# **HDC**

## **ADMINISTRATIVE APPROVALS**

<b>May 07, 2025</b>
---------------------

**A2** REAR ELEVATION - ELECTRICAL PEDESTAL  
Scale: 3/4" = 1'-0"

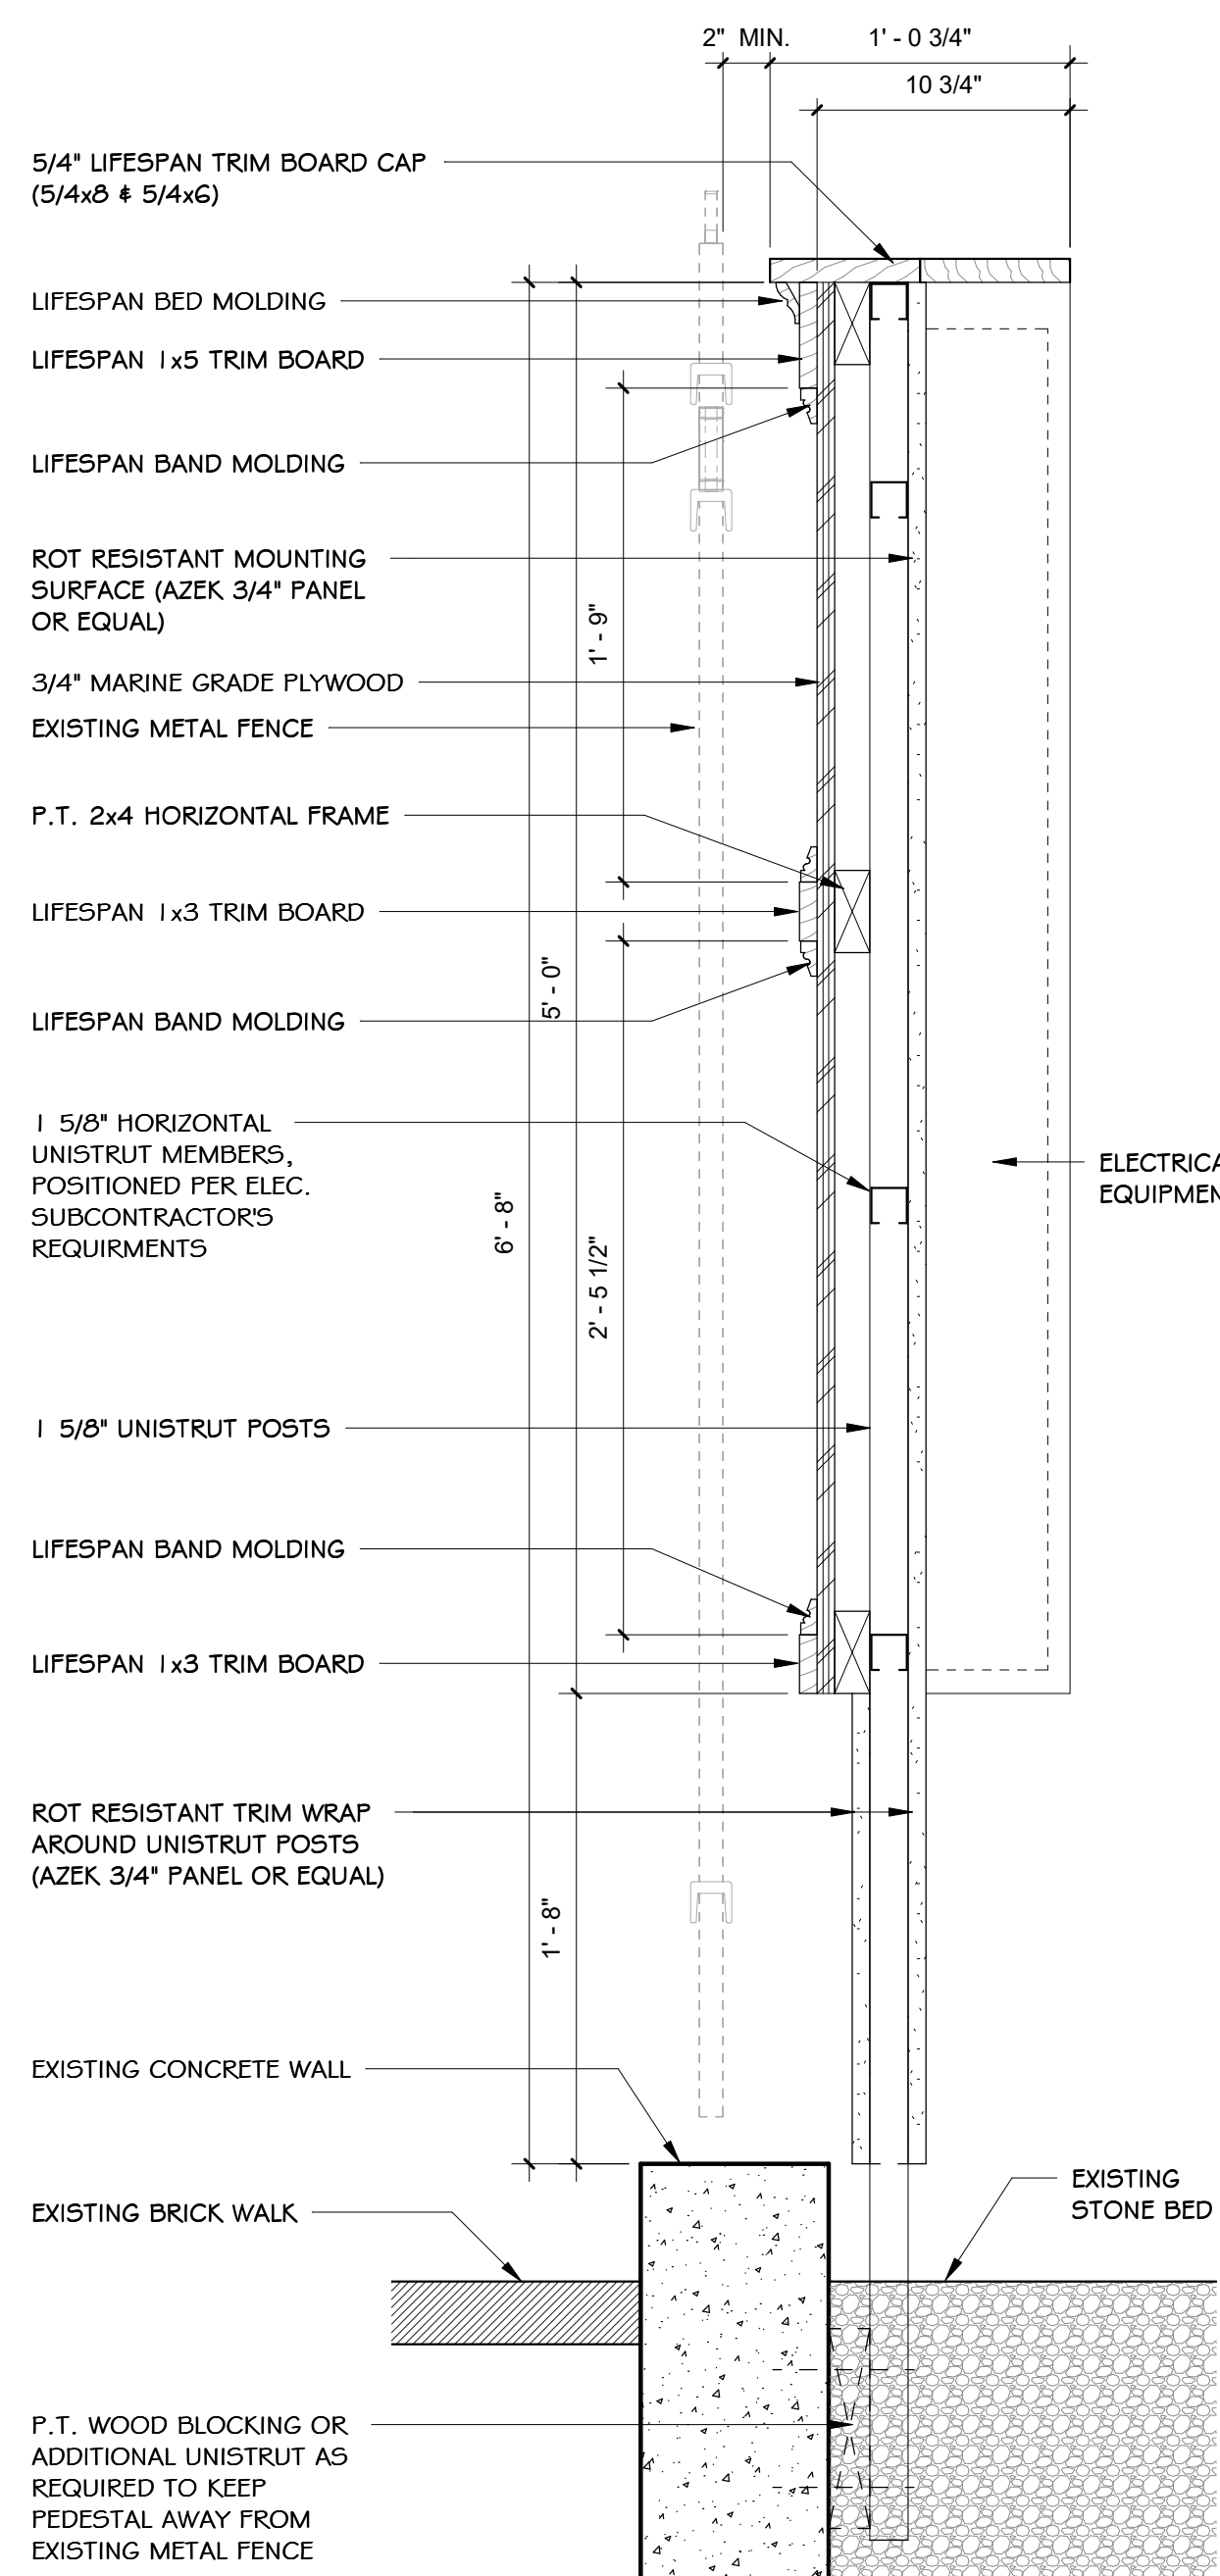
**Background:** The applicant is seeking approval for the removal of the electric meters on the building and move them to a free-standing panel.

**Staff Comment:** Recommended Approval

Right Side

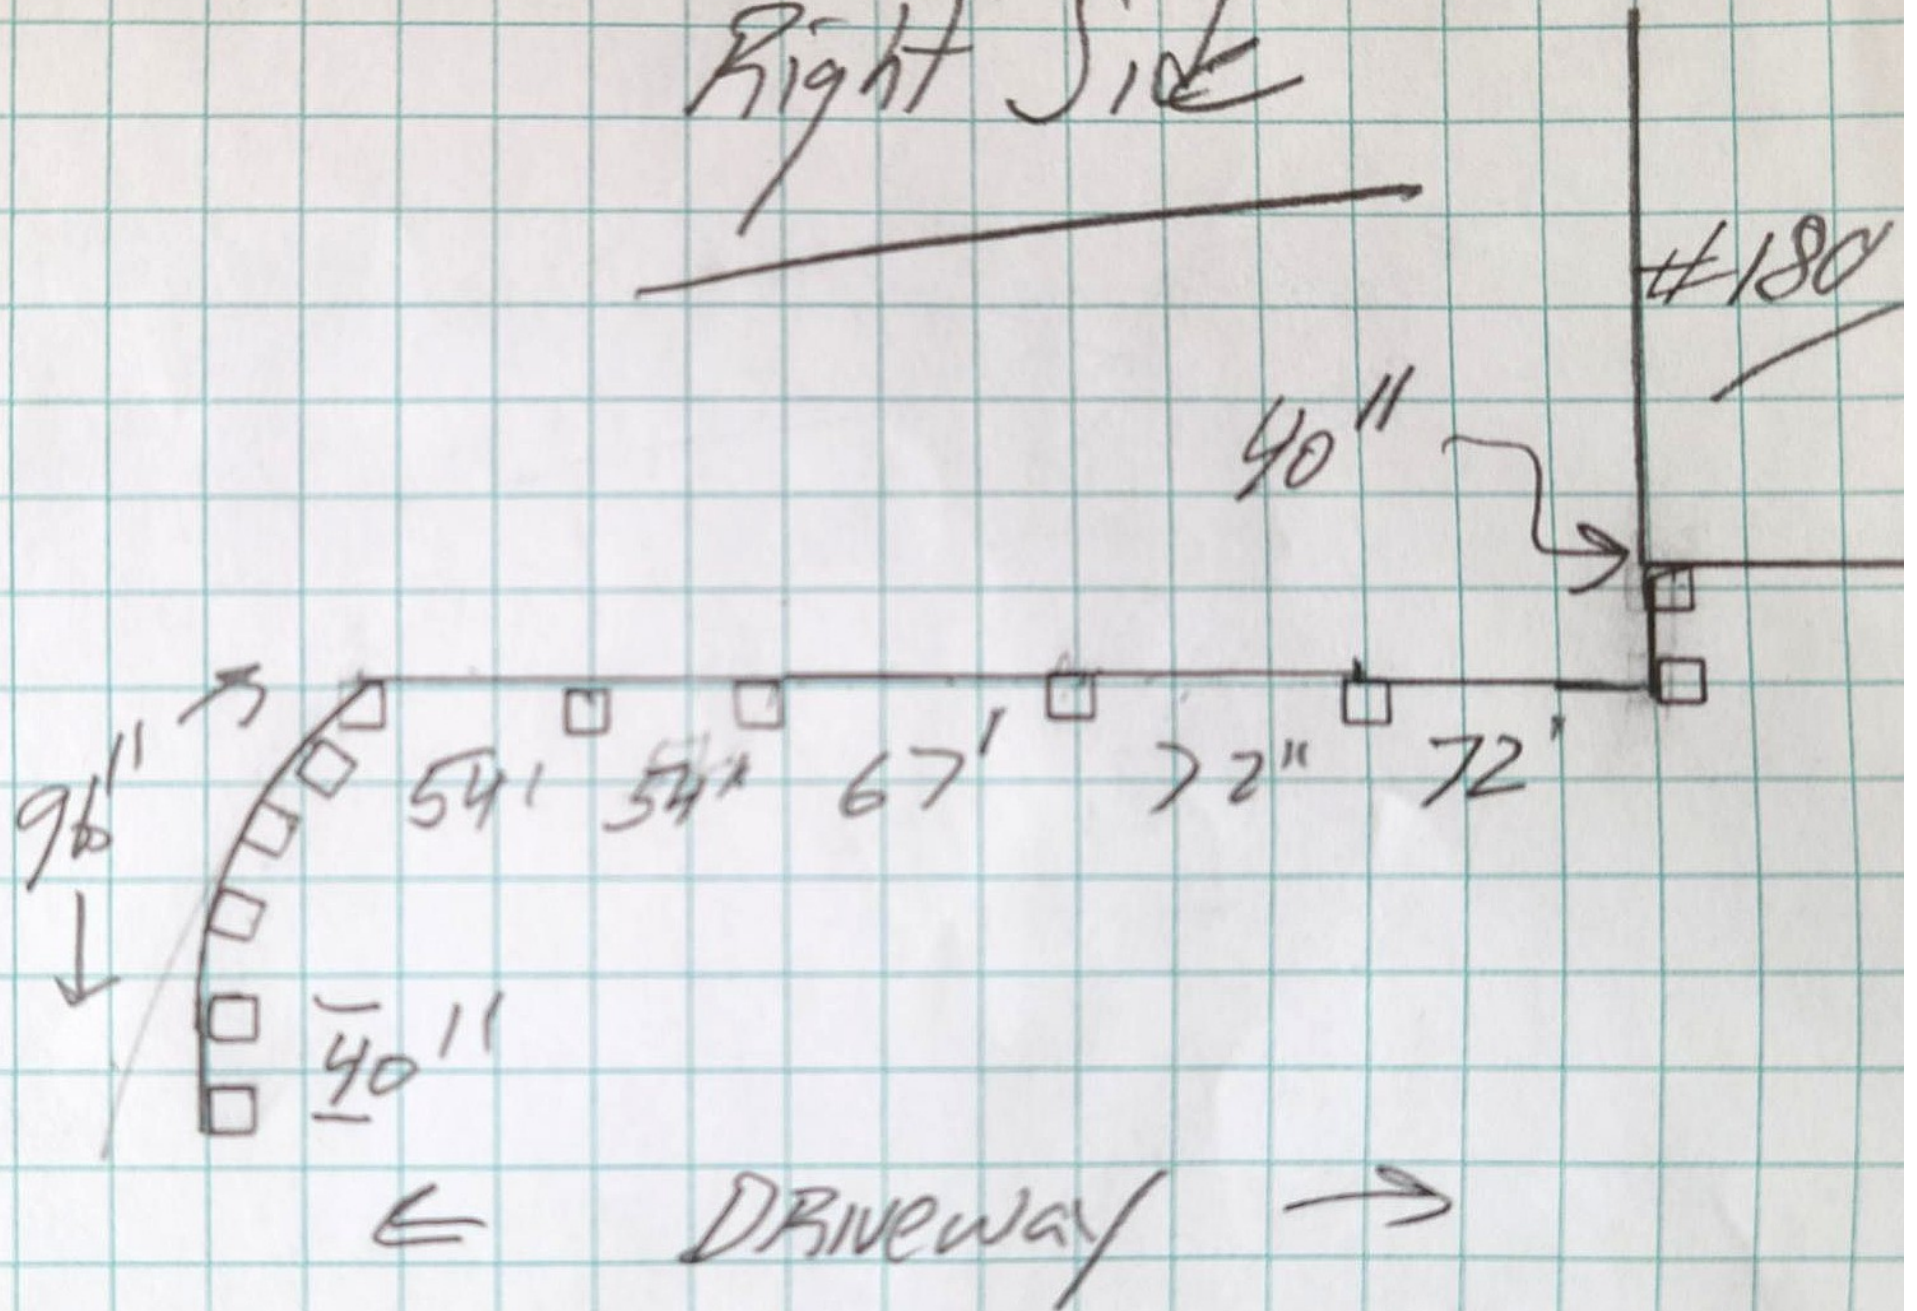
**Background:** The applicant is seeking approval for the replacement of wood fencing on the property with an AZEK material.

**Staff Comment:** Recommended Approval

Revised panel layout

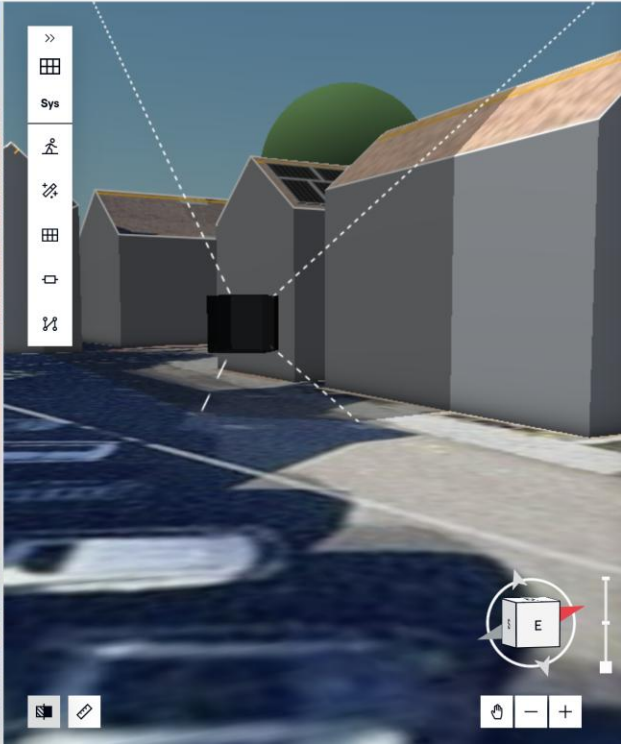
**Background:** The applicant is seeking approval for the installation of solar panels on the garage and the rear roof of the main structure.

**Staff Comment:** Recommend Approval

AA

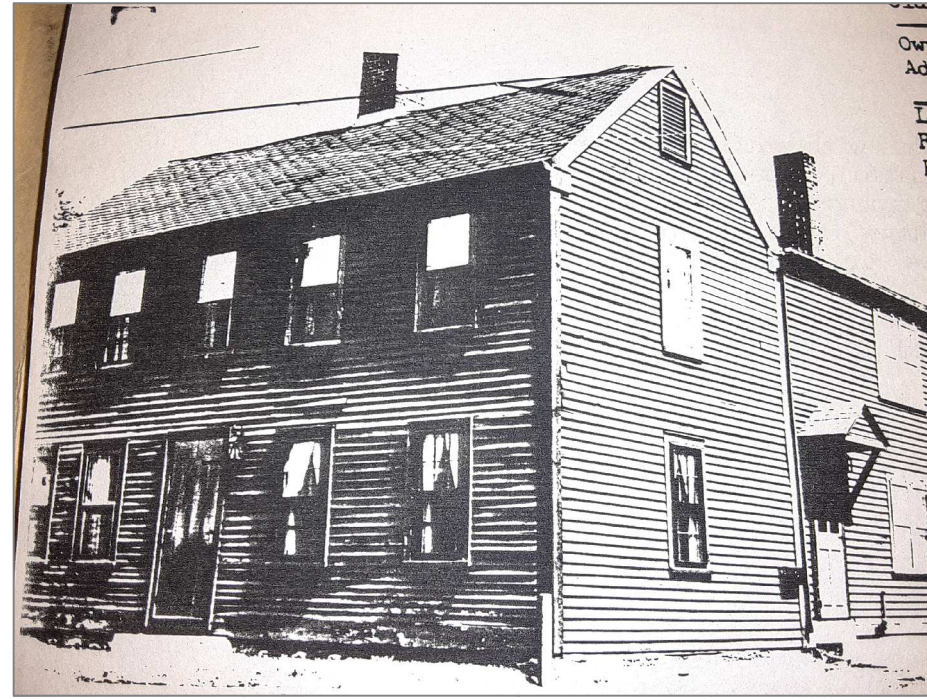
-Image A appears to demonstrate the home had equal 'to weather' siding at the time of the photo.

-Image B appears to demonstrate the home had equal 'to weather' siding on the right side at the time of this photo. We can assume the left side would have been the same. This supports our proposal for the residing the side elevations.

-Image C demonstrates the home was once sided in cedar shingles. This also shows the home has undergone a sizable rear addition and renovation. See existing back elevation Photo 1 on Page 3.

*#40-42 Market Street is one of the only buildings on Market Street with a “flat-faced” doorway. Only the awning protects it (imperfectly) from the weather.*

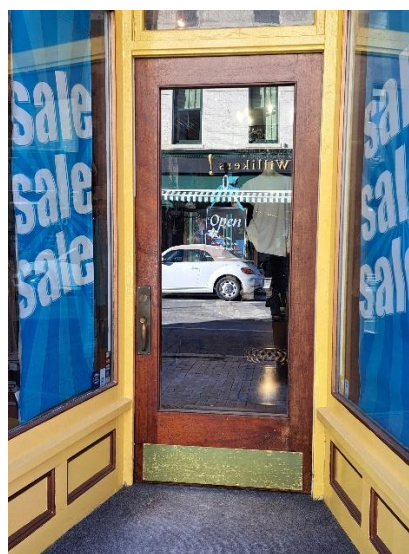
Both the shop door to "Puttin' On the Glitz" and it's frame are badly rotted. As you can see from the images below, it is currently an antique (1920s?) double door, and both sides sag in towards the middle due to rot on both the doors and the framing. We've owned this building since 1982 and have tried to keep the doors always painted and in good repair, but two professional assessments have convinced us that rehanging is no longer an option. It's time to replace both the door framing and the doors themselves.

As you can see from the pictures below, 40-42 Market Street is unusual in that it is almost the only building on the street with a "flat-faced" doorway. Almost every other doorway on the street is recessed in some way and therefore better protected from the elements. While our building has an awning, this imperfectly protects the door and its frame from rain and snow. Because of this, we would like to replace the door's frame with a composite material which won't rot. We'd like to keep the door wooden, however.

Because I've been unable to find new doors similar to the antique double doors we have now, and because the owner of "Puttin' On the Glitz" would like a door which would be easier for her customers to open and close, and would be more handicap accessible, we would like to replace the double doors with a single one. I have included pictures of several doors currently found on Market Street, any of which we would consider as a replacement style, based upon your recommendations.

- which door style might be acceptable
- if we could frame the door using composite materials rather than wood
- anything else a contractor might need to know about this job.
